Development Services Staff Report

File Number	PL2023-093
File Name	REZONING from CP-2 to PMIX – Pryor Mixed-Use
Applicant	Griffin Riley Property Group, applicant
Property Address	1805 & 1905 SW M-150 Hwy.
Planning Commission Date	August 10, 2023
Heard by	Planning Commission and City Council
Analyst	C. Shannon McGuire, Senior Planner
Checked By	Dawn Bell, Planning Manager Aimee Nassif, AICP, Deputy Director of Development Services Sue Pyles, PE, Development Engineering Manager

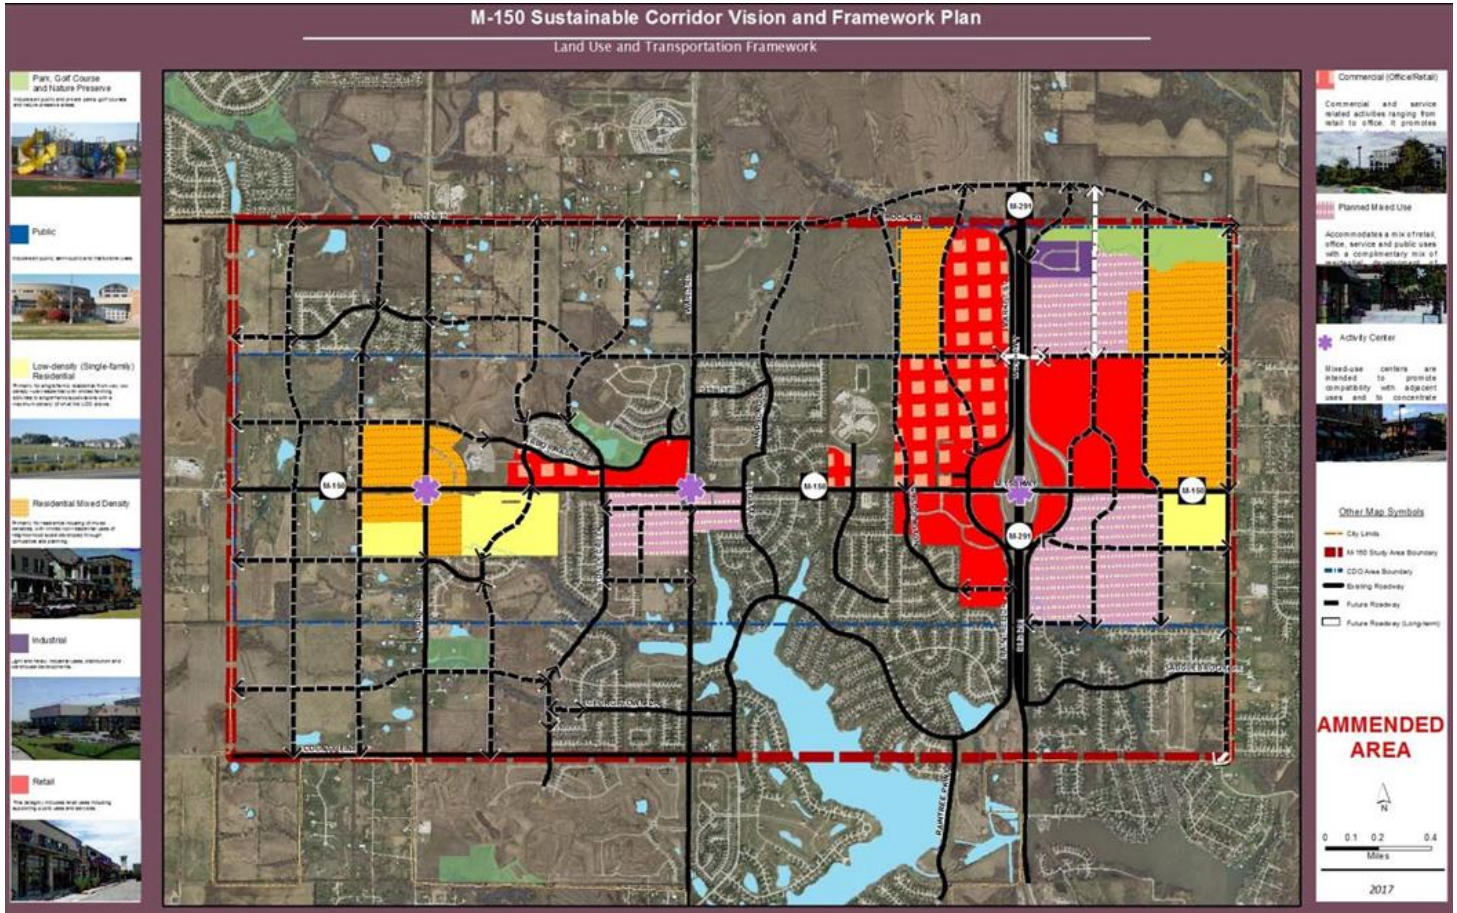
3. The applicant has requested a modification to UDO Sec. 6.040 – Minimum building setbacks.

- **Required** – 50’ building setback from major streets (SW Pryor Rd)
- **Proposed** – 30’ building setback from major streets (SW Pryor Rd)
- **Recommendation** – The applicant has proposed to place the detached garage buildings approximately 30’ from the SW Pryor Rd ROW however the UDO requires a 50’ building setback along major roads. To utilize the site effectively, meeting the UDO setback requirement would result in the required parking lots being placed between the proposed buildings and the roads. Good planning principles discourage this approach as it does not create an appealing streetscape nor is it pedestrian friendly. Situating the structures as proposed, the buildings will act as a visual screen and physical buffer. This will activate the area and provide an improved streetscape with a more appealing pedestrian friendly environment. To help soften the impact the applicant has added additional architectural elements to the rear of the garages to include windows, awnings

and stone veneer, as well as additional vegetation in the form of bushes and trees. Staff finds the request reasonable and for these justifications supports the requested modification.
